Access Compliance Report

Public Rights-of-Way

Intersection ID: 48426	Main Street: EVANTON_LOCH_RD	Cross Street: ROUSAY_RD	Location: SW
ADA ID: 434F5766D8DB	Ramp Type: PerpDiag	Initial Pass/Fail: Fail	Overall Compliance: No
			Severity Score: 21.25

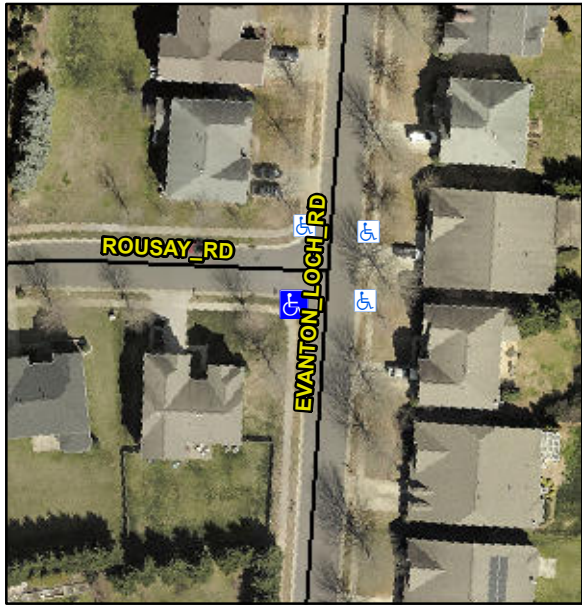
Codes/Mitigation Info/Possible Solution			Field Measurements/Component Compliance					
	Possible Solutions:		Compliance	Description	Data	Compliance	Description	Data
	Remove & Replace Curb Ramp With Two New Directional Ramps or Equivalent.		N/A	Ramp Length (in)	47.5	No	Ramp Slope (%)	11.6
			No	Ramp Width (in)	46.0	Yes	Ramp XSlope (%)	0.7
			N/A	Flare Type LT	N/A	N/A	Flare Type RT	N/A
			N/A	Flare Slope LT (%)	N/A	N/A	Flare Slope RT (%)	N/A
			N/A	Flare Traversable LT?	N/A	N/A	Flare Traversable RT?	N/A
			N/A	Landing Length (in)	N/A	N/A	DWS Provided?	N/A
			N/A	Landing Width (in)	N/A	N/A	DWS Contrast?	N/A
			N/A	Landing Slope (%)	N/A	N/A	DWS Length (in)	N/A
			N/A	Landing X Slope (%)	N/A	N/A	DWS Full Width?	N/A
Surveyor Notes:		N/A	N/A	Landing Curb? (Y/N)	N/A	N/A	DWS Offset (in)	N/A
PROW/ADA:		R304.5.1, R304.2.2	N/A	Shared Landing?	N/A			
			N/A	Gutter Ponding?	N/A	N/A	Gutter Slope (%)	N/A
			N/A	Gutter Lip Ht (in)	N/A	N/A	Gutter X Slope (%)	N/A

N/A	Painted X Walk1?	No	N/A	Painted X Walk2?	No
				X Walk 1 Direction	To SE		X Walk 2 Direction	To NE
			N/A	X Walk 1 Width (in)	N/A	N/A	X Walk 2 Width (in)	N/A
				X Walk 1 Slope (%)	1.9		X Walk 2 Slope (%)	1.9
				X Walk 1 X Slope (%)	1.2		X Walk 2 X Slope (%)	1.6
			N/A	Ramp inside XWalk1?	N/A	N/A	Ramp inside XWalk2?	N/A
				Road Slope (%)	0.3	N/A	Clear Space?	N/A
				Road X Slope (%)	1.4	N/A	Clear Space to XWalk (in)	N/A
			N/A	Any Obstructions?	N/A	N/A	Storm Grate/Utility Hazard?	N/A
				Obstruction Type			Storm Grate/Utility Type	
					N/A			N/A
						Yes	Surface Condition? (G/P)	Good
